LOCATION: San Jacinto Street, southwest of Carroll Avenue**DATE FILED:** January 9, 2026**ZONING:** PD 298 (Subarea 4)**PD LINK:** <https://dallascityhall.com/departments/city-attorney/pages/articles-data.aspx?pd=298>**CITY COUNCIL DISTRICT: 2****SIZE OF REQUEST:** 0.261-acres**APPLICANT/OWNER:** Cedar Rock Development, LLC**REQUEST:** An application to replat a 0.261-acre tract of land in City Block 16/647 to create one lot on property located on San Jacinto Street, southwest of Carroll Avenue.**SUBDIVISION HISTORY:**

STAFF RECOMMENDATION: The request complies with the requirements of PD 298 (Subarea 4); therefore, staff recommend approval of the request subject to compliance with the following conditions:

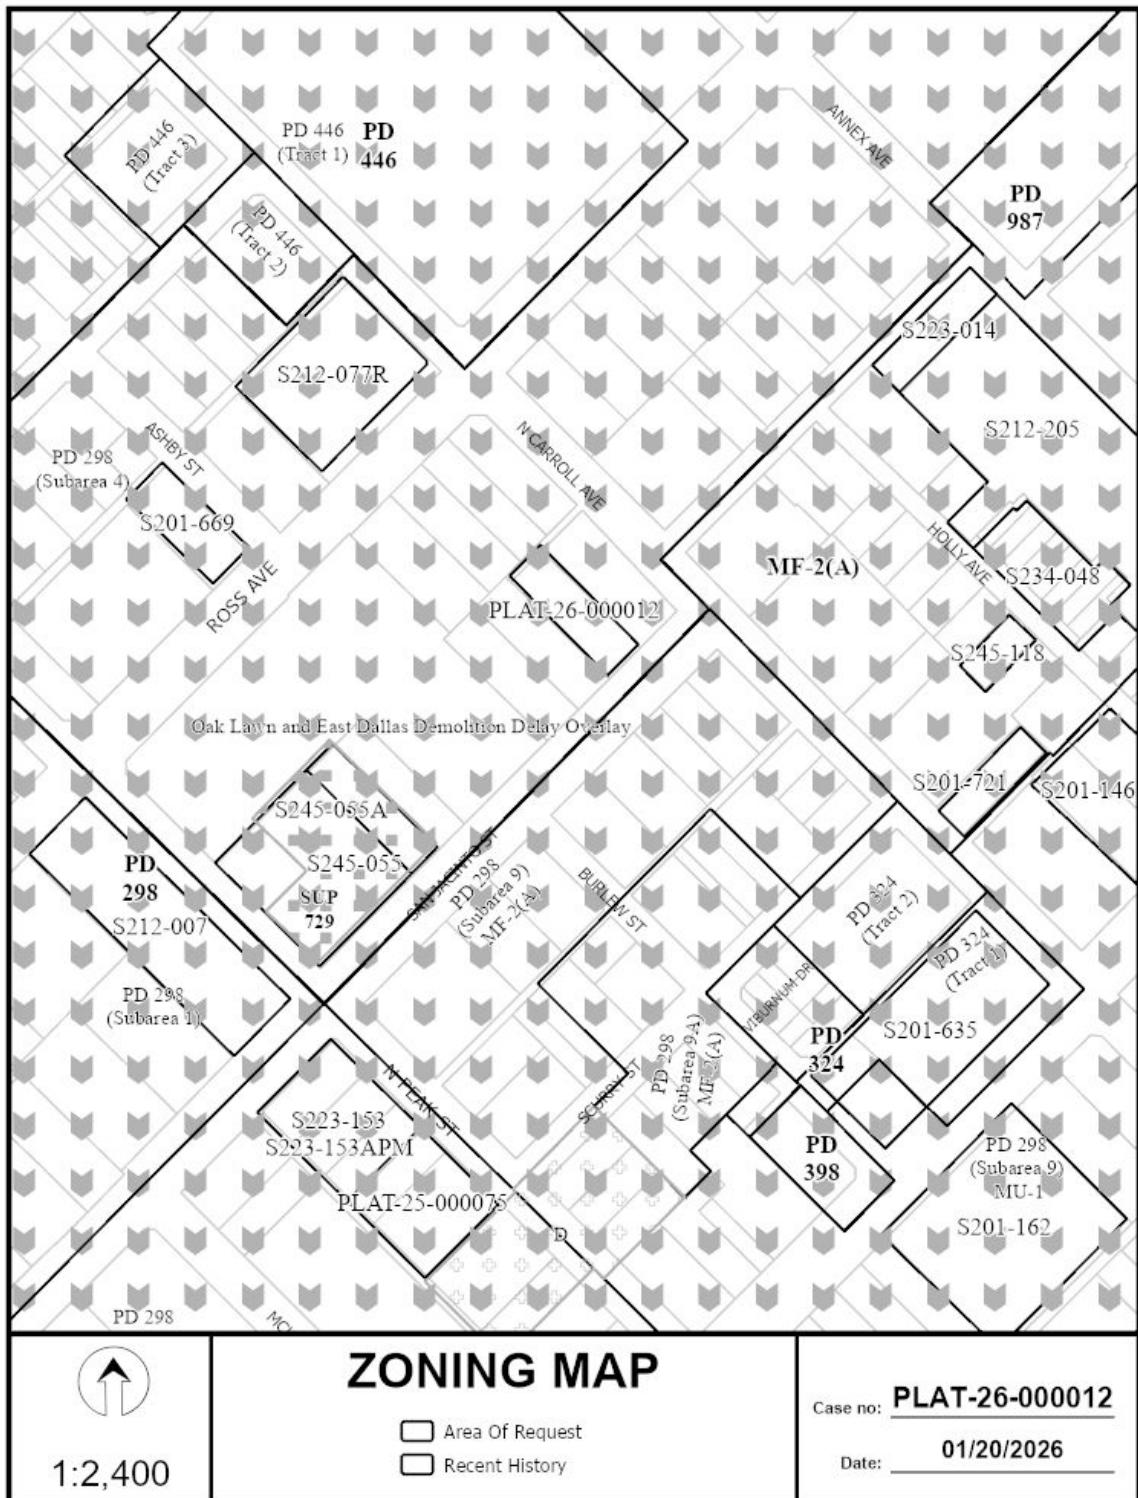
17. Submit a completed Final Plat Checklist and All Supporting Documentation.
18. Show all additions or tracts of land within 150 feet of property with recording information.
19. Need new/different plat name.
20. Show Instrument Number 20080280937, Official Public Records, Dallas County, Texas.

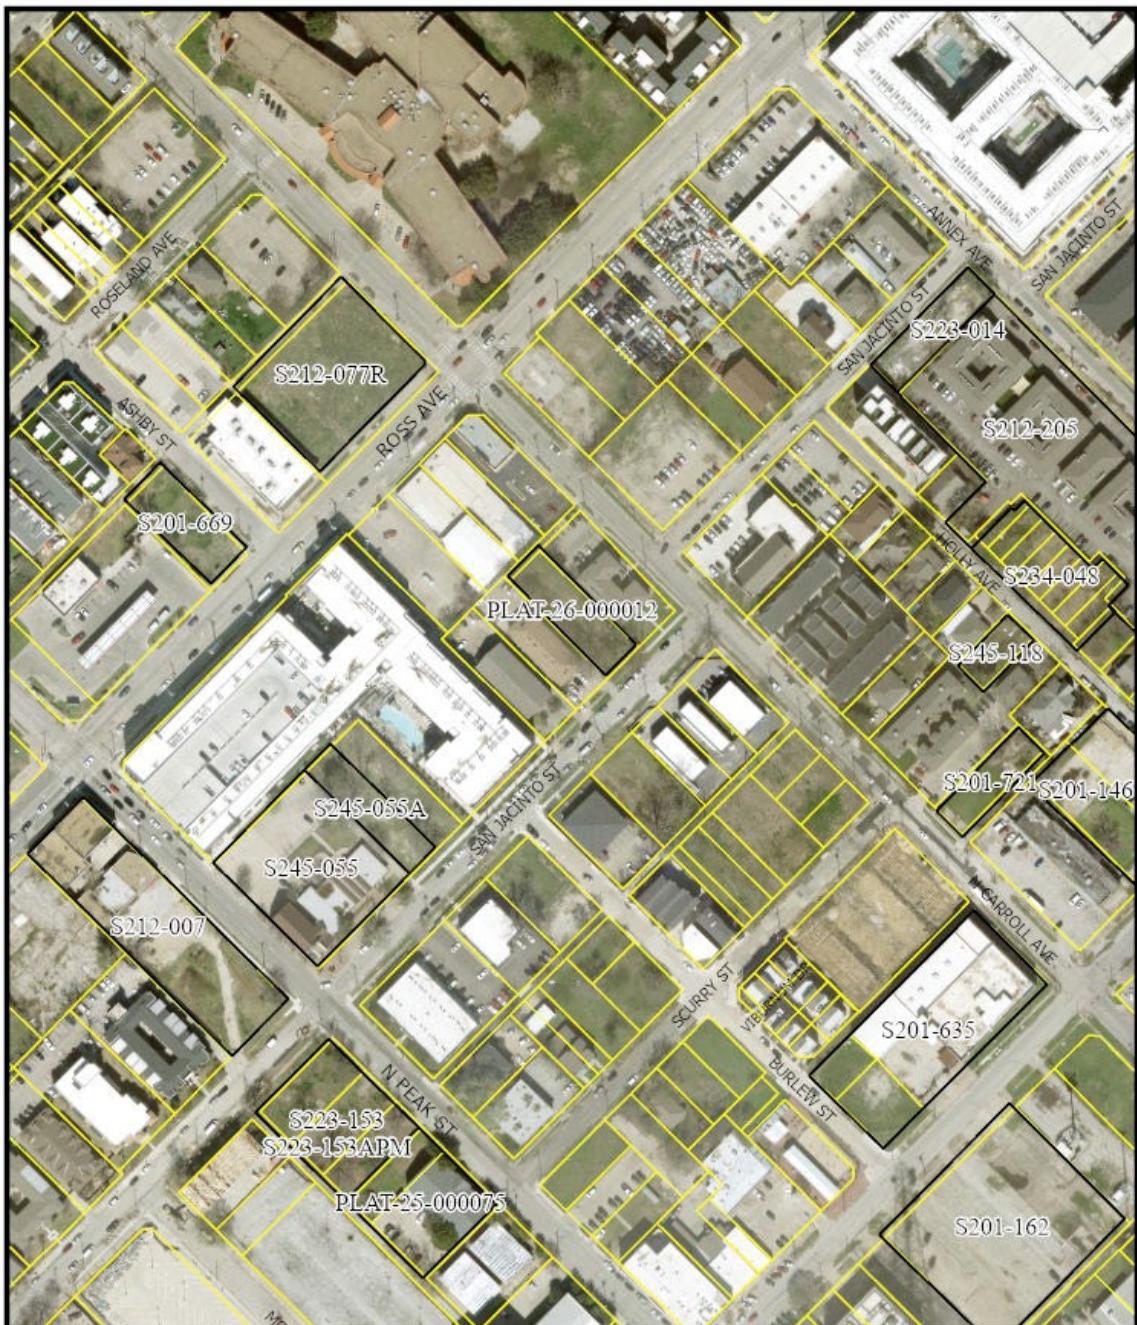
23. On the final plat, change “North Carroll Avenue” to “Carroll Avenue (AKA Carroll Street)”.
24. Remove the fence and two gate post encroachments in San Jacinto Street right-of-way and fence encroachment in alley.
25. On the final plat, identify the property as Lot 23A in City Block 16/647.
